# CITY OF CONWAY, ARKANSAS HISTORIC DISTRICT COMMISSION

March 27, 2023 • 5:30pm • 1111 Main Street

# 125 Center Street - Awning & Shade Structure Additions

# 1169 Mitchell Street - Residential Addition

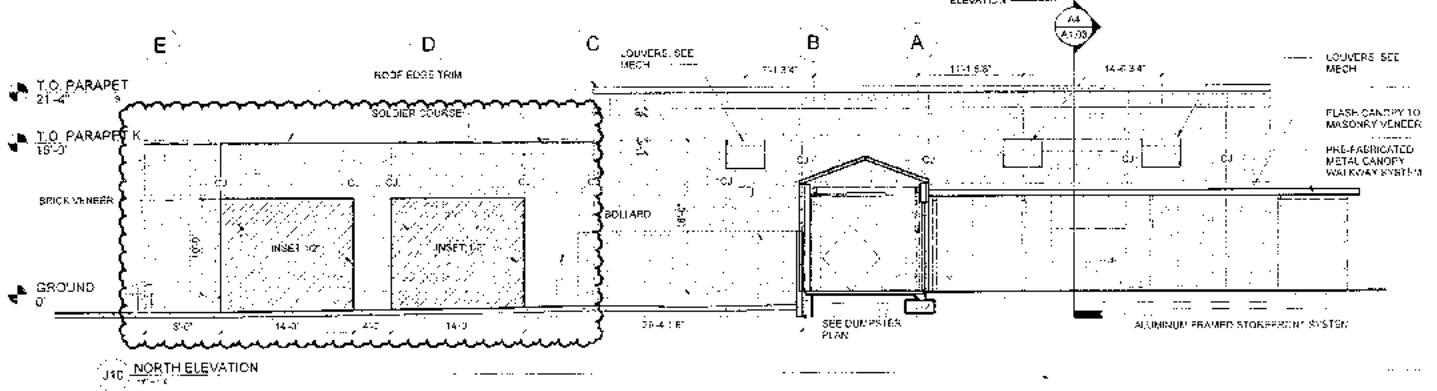
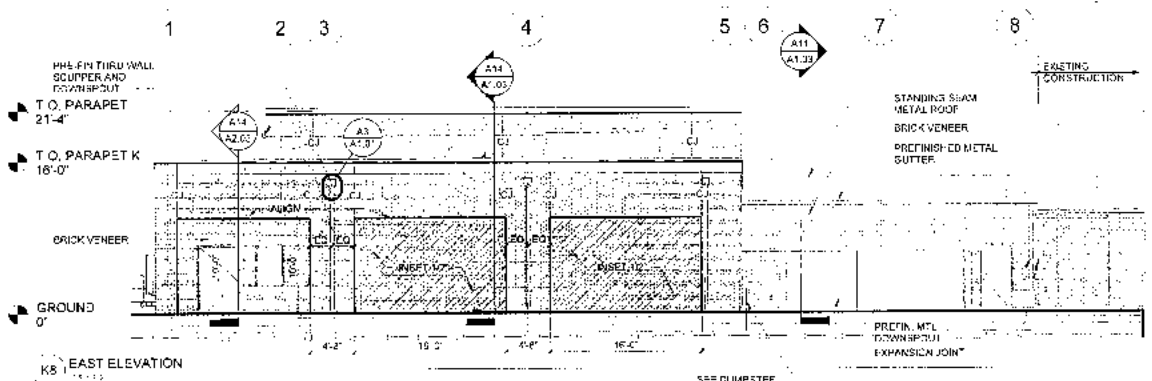
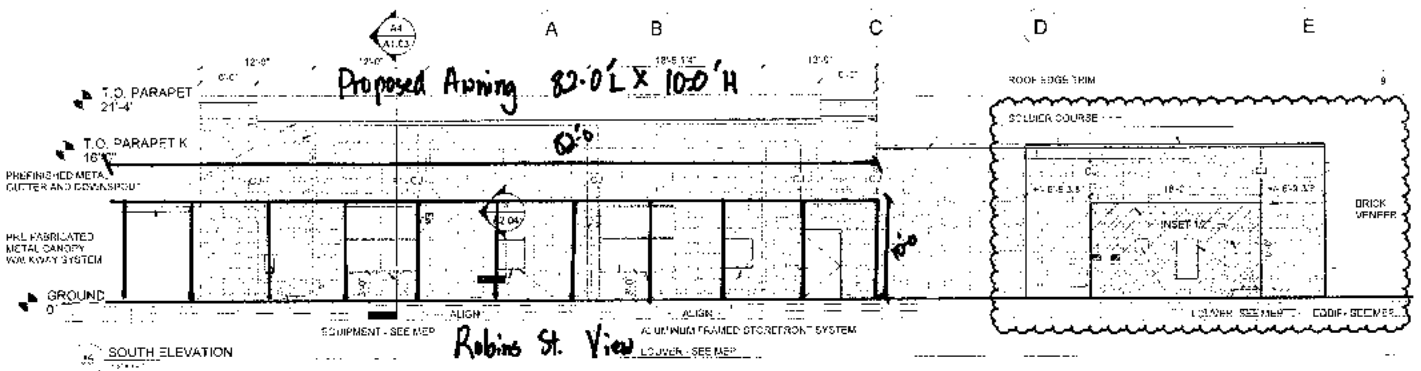
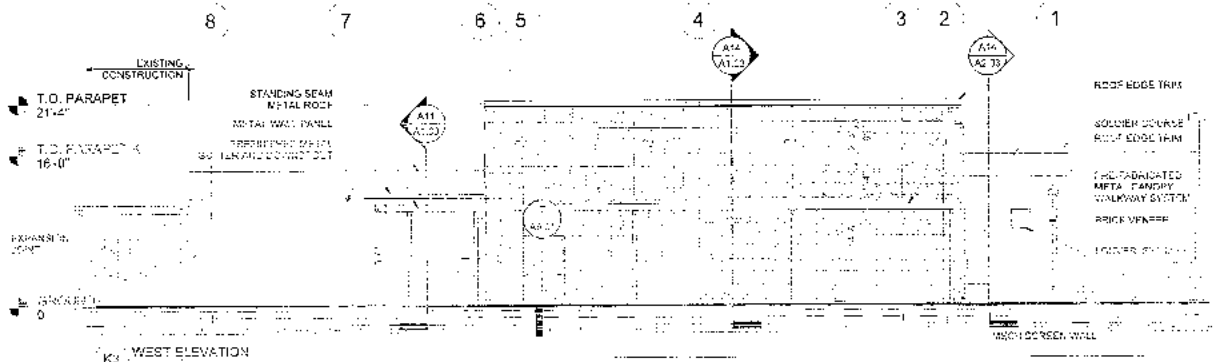
*The new awning will be visible from Robins St. Landscaping was installed during construction that will somewhat aid in screening once trees mature. It is recommended that the awning match the existing awning to ensure cohesiveness of the site.*

*The three canopies will be visible from South Blvd. Existing landscaping exists which will provide a level of screening. The new canopies will likely be more visually appealing when compared to the current metal structures.*

Staff recommends approval of the application with the following conditions:

1. New awning along Robins St must match existing awning in material, color, and design.
2. All existing metal canopies must be removed permanently from the site.
3. Any change to the configuration or number of canopies will require a new Certificate of Appropriateness granted by the Historic District Commission.

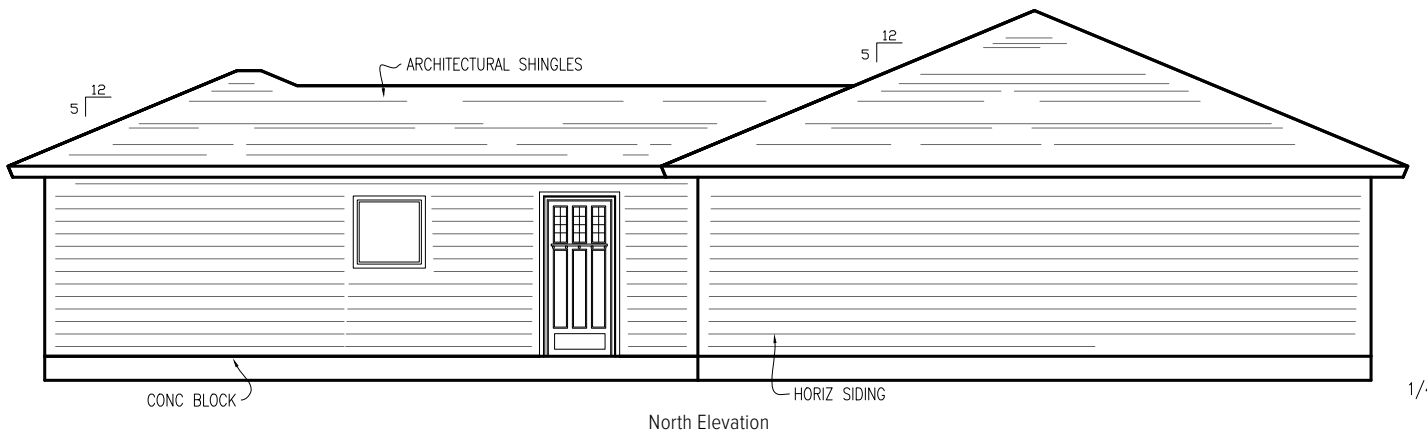
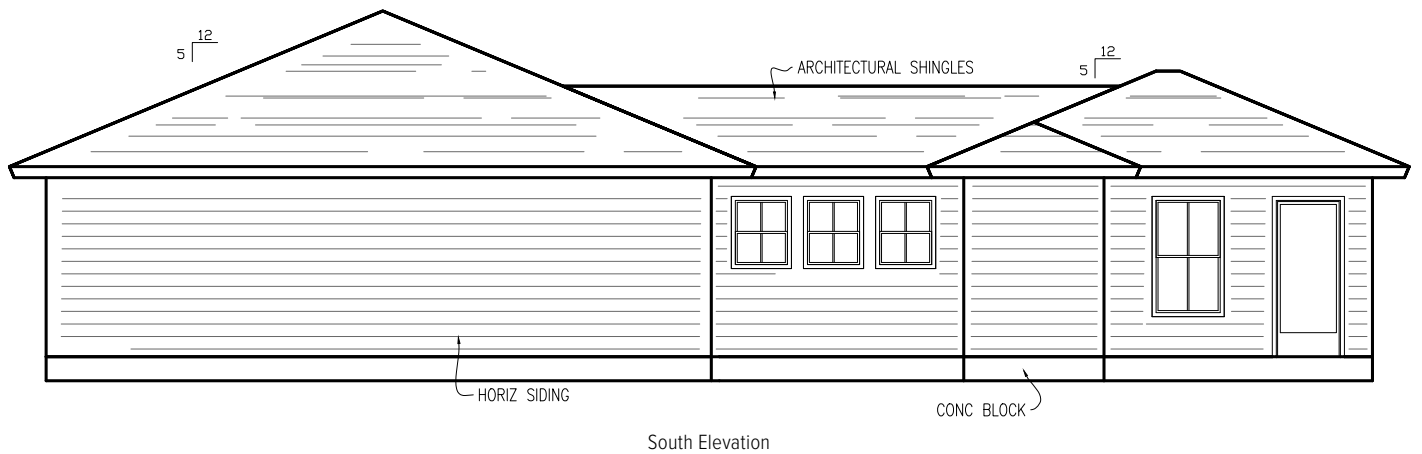
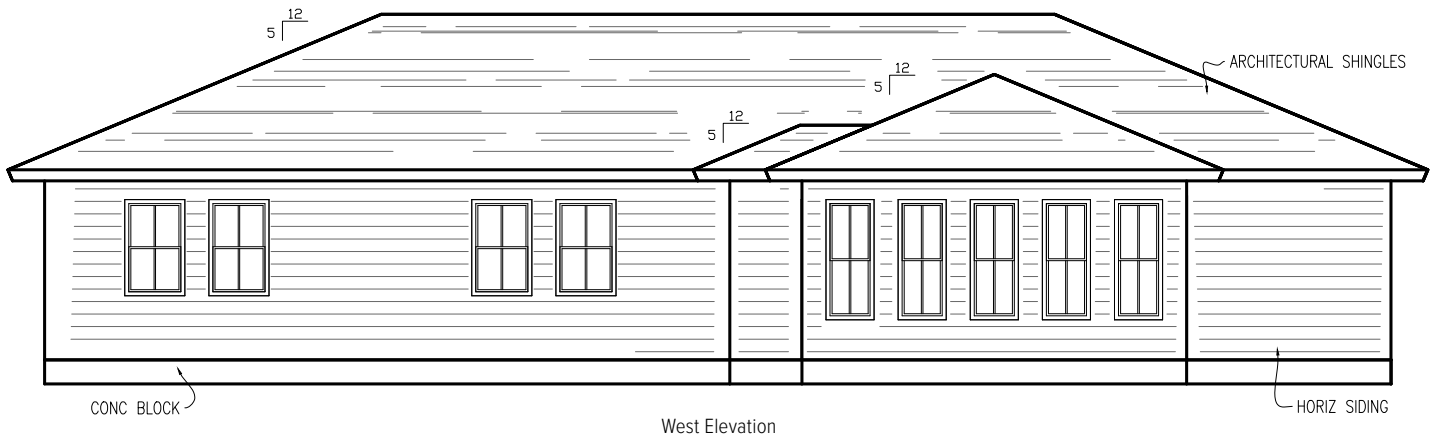
*The addition is located at the rear of the structure in an appropriate manner. The scale of the addition does not visually overpower the existing structure. The proposed cladding of Hardie® lap siding is an appropriate historic material.*

One-over-one windows are proposed. Window type is appropriate, however fake muntin bars are prohibited. If muntin bars are proposed, they must be true divided lights.

The roof is proposed to be architectural shingles. This is appropriate.

Staff recommends approval of the request as proposed with the following conditions:

- 1. Windows shall match the style of the existing primary structure. If muntin bars are used they shall be true divided lights (fake muntin bars are prohibited).

① East  
1/4" = 1'-0"

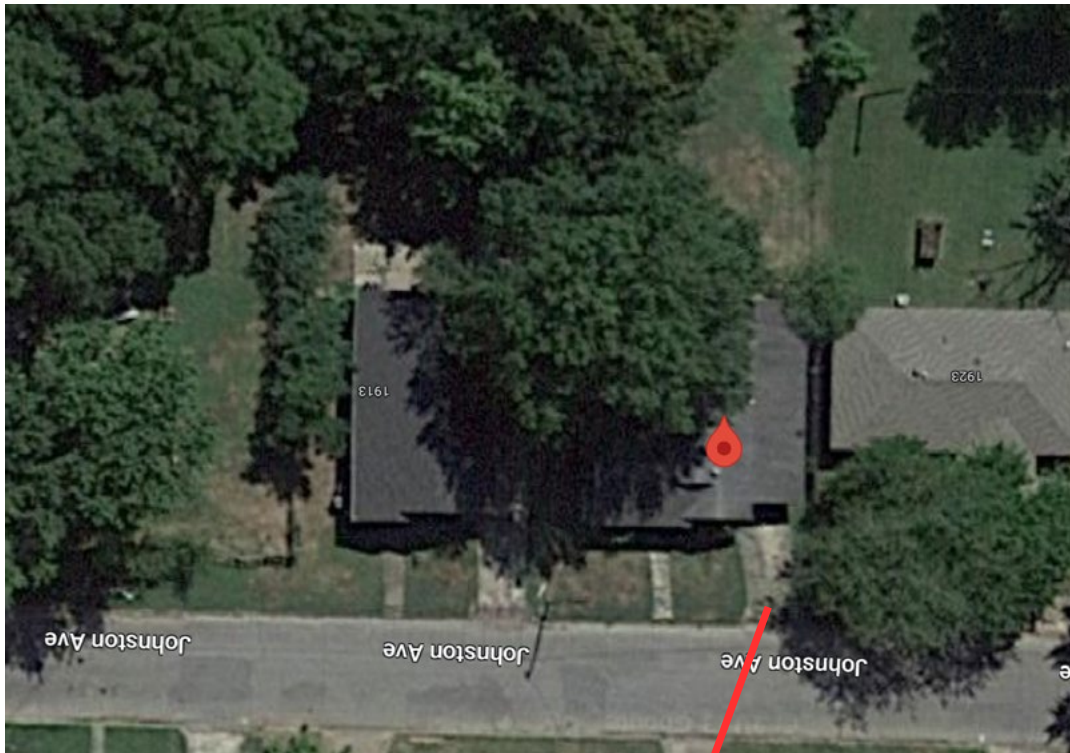
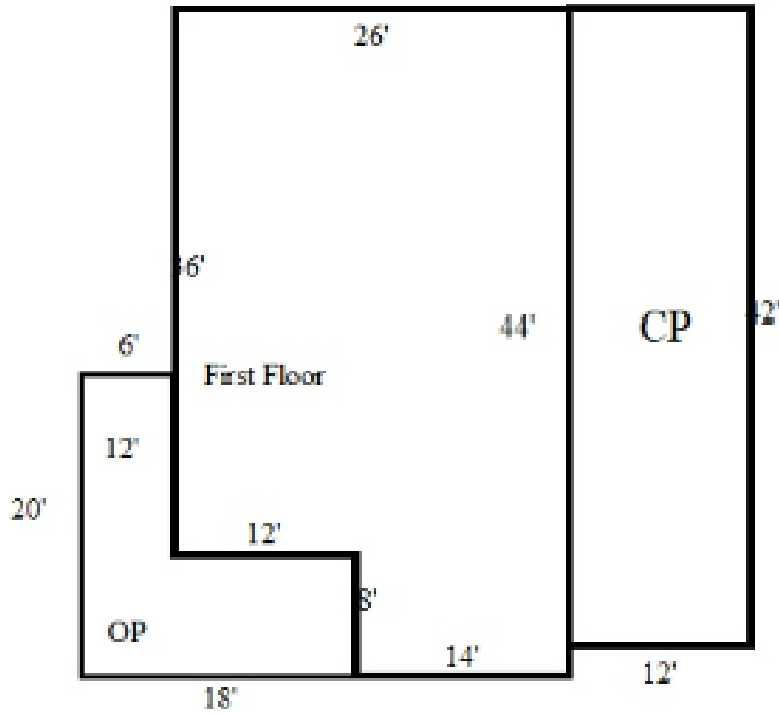
*The applicant has removed some windows from the structure and some have been replaced. Recommend requiring replacement with one-over-one windows matching the original sizes.*

*There are no changes to the porch area. Door replacement must be compatible with the area and consistent with HDC guidelines. Recommend window replacement with one-over-one windows matching the original size.*

*Recommend asphalt shingles for any roof repairs/reroofing. No changes to be made to the pitch or design of the roof.*

Staff recommends that the application be approved with the following conditions:

1. Applicant must obtain all applicable building permits if/when a Certificate of Appropriateness is granted.
2. All windows will be required to be one-over-one.
3. All fascia and soffits shall be repaired with wood or a wood-like material such as Hardie® siding/LP SmartSide®.
4. Roofing shall be composed of asphalt shingles.
5. No shutters shall be allowed.
